Archway gyratory consultation; Islington Council's technical response

This letter forms Islington Council's technical response to Transport for London's (TfL) recent public consultation on the proposals for Archway gyratory. This is in addition to the Council's formal response letter to the Mayor of London from Councillor Claudia Webbe.

Proposals to introduce two-way traffic at Archway gyratory and relocate the Vorley Road bus stand

Note for London Buses

SDG10

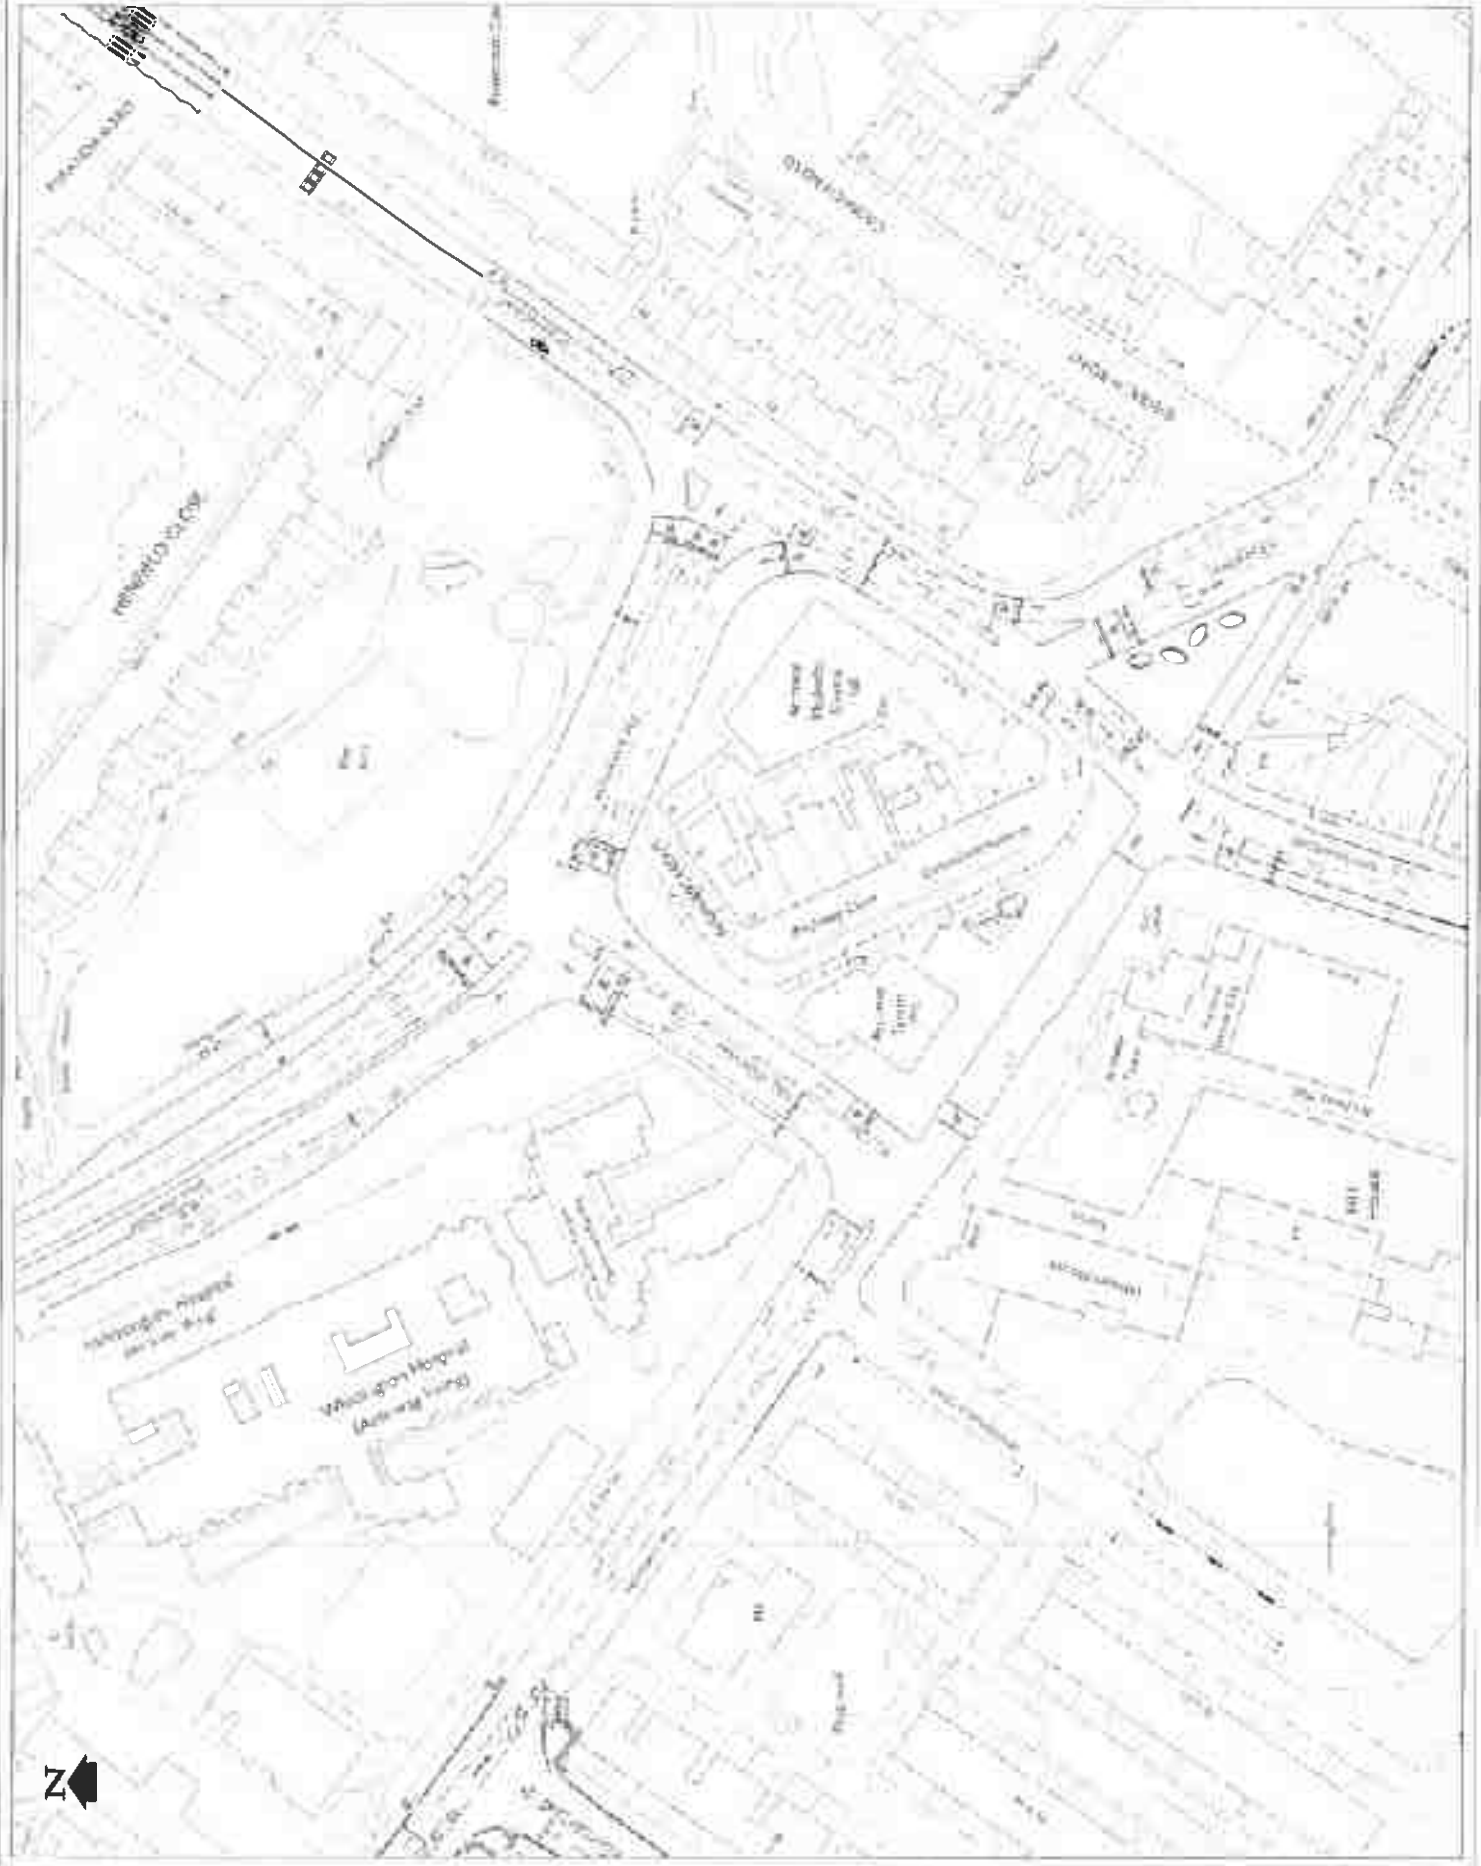
- 3 The designs presented at the Network Management Group proposed to close the Lower Highgate Hill arm of the existing gyratory and the northern end of Holloway Road to general traffic (providing northbound bus and cycle access only). Two-way traffic would be introduced on the other sides of the gyratory, and the A1 (Archway and Holloway Roads) would be aligned on the eastern side of the gyratory. The layout for this option (also known as SDG10) is shown at Appendix 1.

- Although the proposals (with and without the bus stand) would provide journey time savings to some bus routes, a number of bus routes would experience delays, some in excess of 90 seconds. If additional buses need to be added to the service because of the delays, this would result in a substantial increase in cost to TfL per additional bus (purchase cost plus additional operating cost).

SDG13a

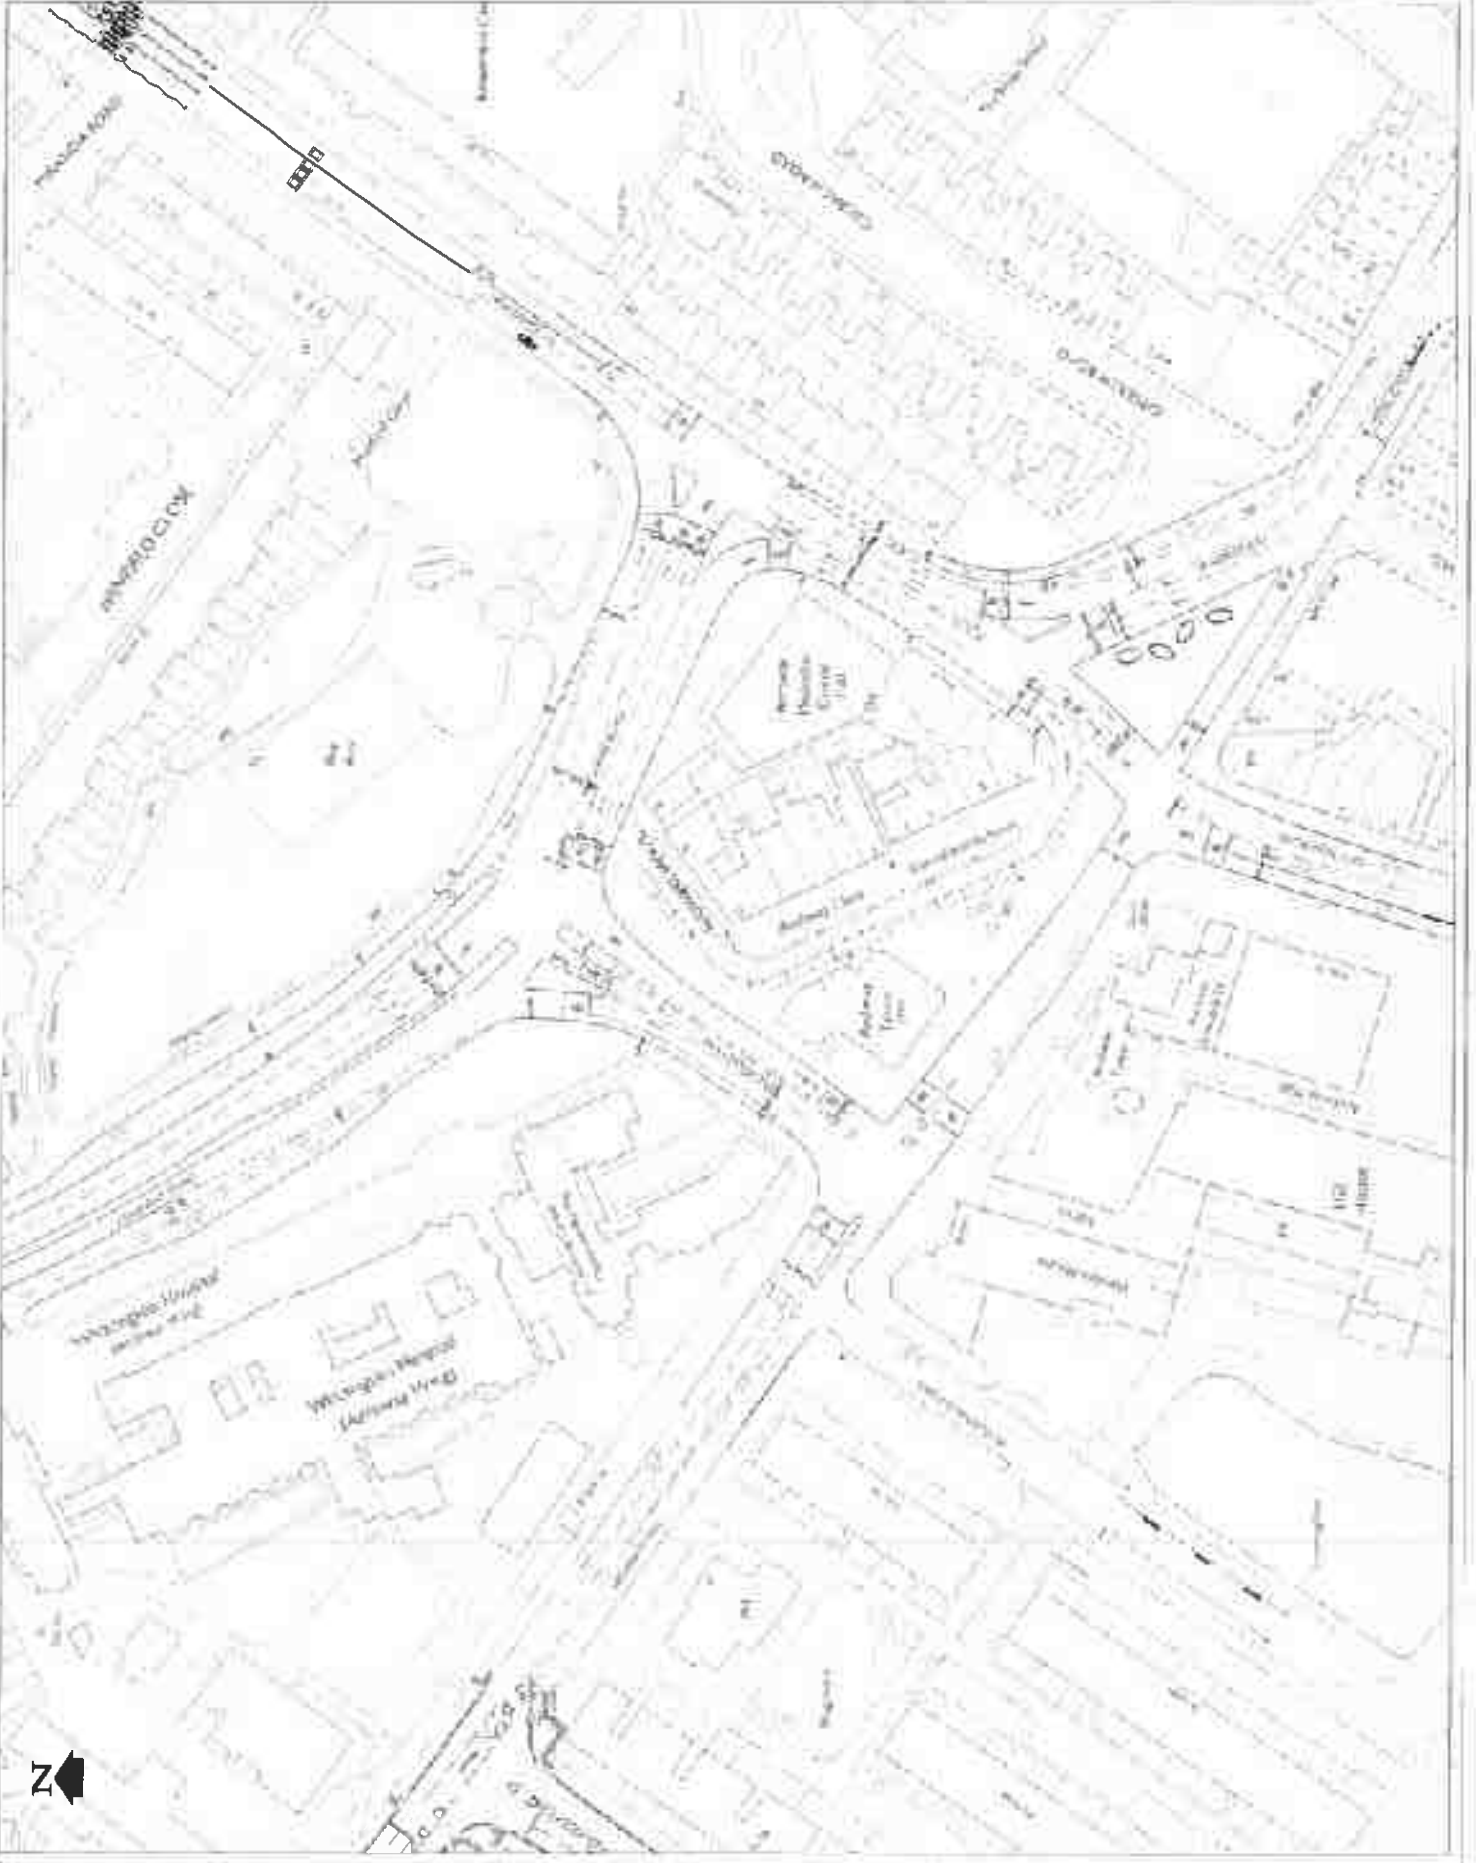
- 7 Variation SDG13a (refer to Appendix 2) proposes to:
 - change the layout and signal timings of the junction of Lower Highgate Hill / Tollhouse Way to split ahead and right-turning buses travelling from Lower Highgate Hill to Highgate Hill or Tollhouse Way.

- change the layout and signal timings of the Archway Road / Tollhouse Way junction to split the left-turning and right-turning movements from Tollhouse Way into Archway Road.

- improve the southbound bus gate on Archway Road to provide more bus priority.
- 8 Variation SDG14a (refer to Appendix 3) proposes the same above changes as SDG13a, but with the relocated bus stand. It is proposed to move bus stands to the following locations (refer to Appendix 4):

SDG14a

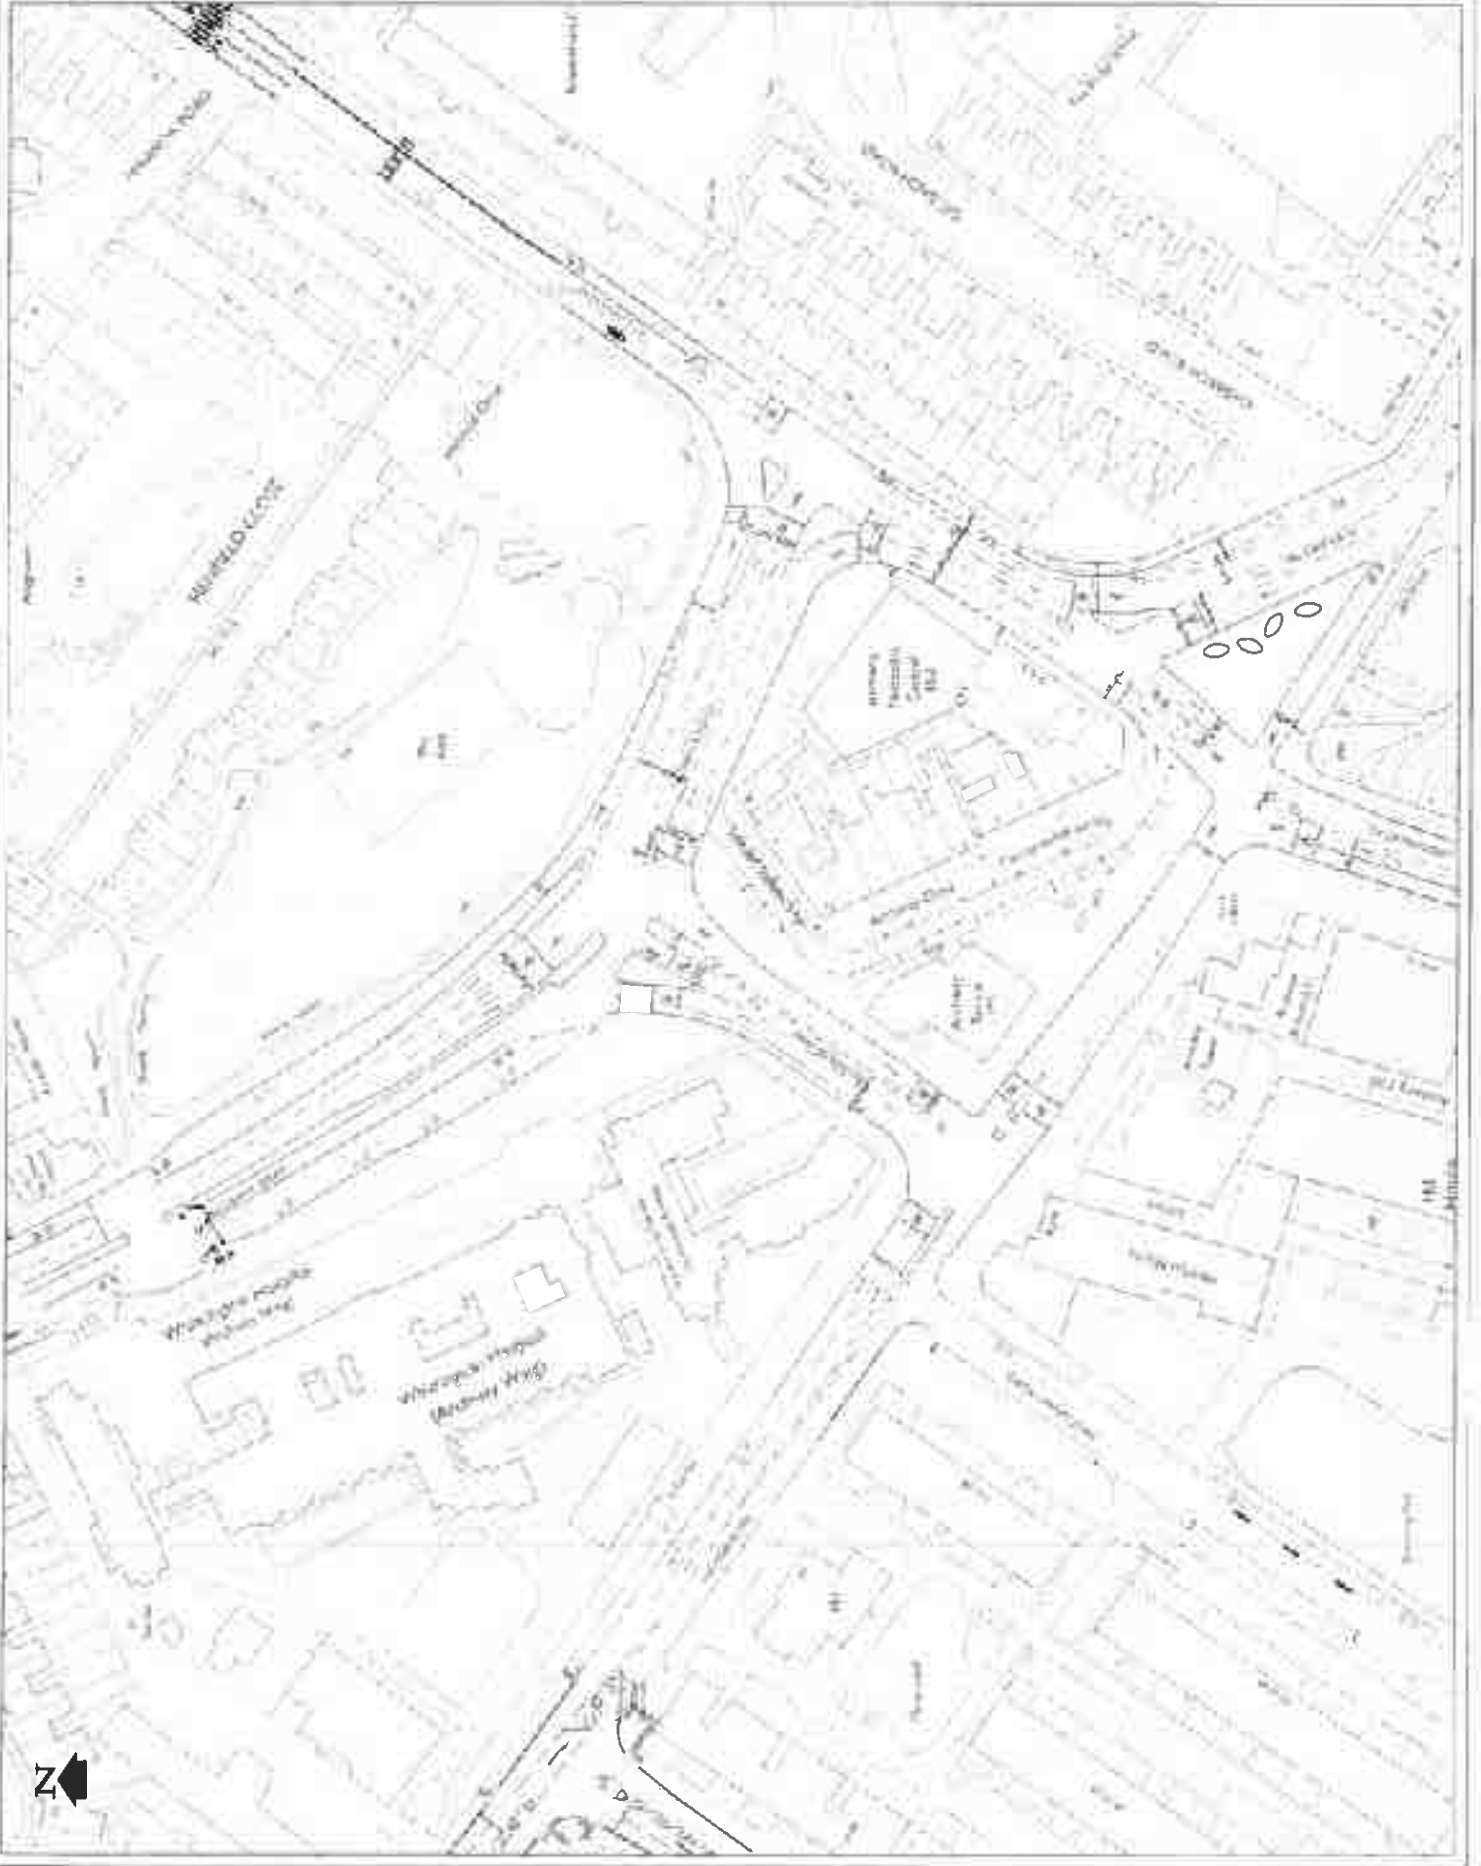
- Archway Road northbound (replacing the bus stops): Routes 17 and 390 (introducing a bus U-turn on Archway Road)
 - Archway Road southbound (replacing the bus stops): Route 143 (introducing a bus U-turn on Archway Road)

- Highgate Hill southbound: Route W5
 - MacDonald Road along leisure centre: Routes 4 and C11
 - Junction Road behind the northbound bus stop: Route 41
- 9 Variation SDG14c is the same as SDG14a, but proposes to swap the bus stand locations of Routes 4 and 143, so that Route 4 is on Archway Road (southbound) and Route 143 is on McDonald Road. As part of this variation, it is proposed to re-route Route 4 (along Junction Road instead of Magdala Avenue) to deliver further journey time savings. Please note that the impact on the Dartmouth Park Hill and Magdala Avenue area of this re-routing has not been assessed.
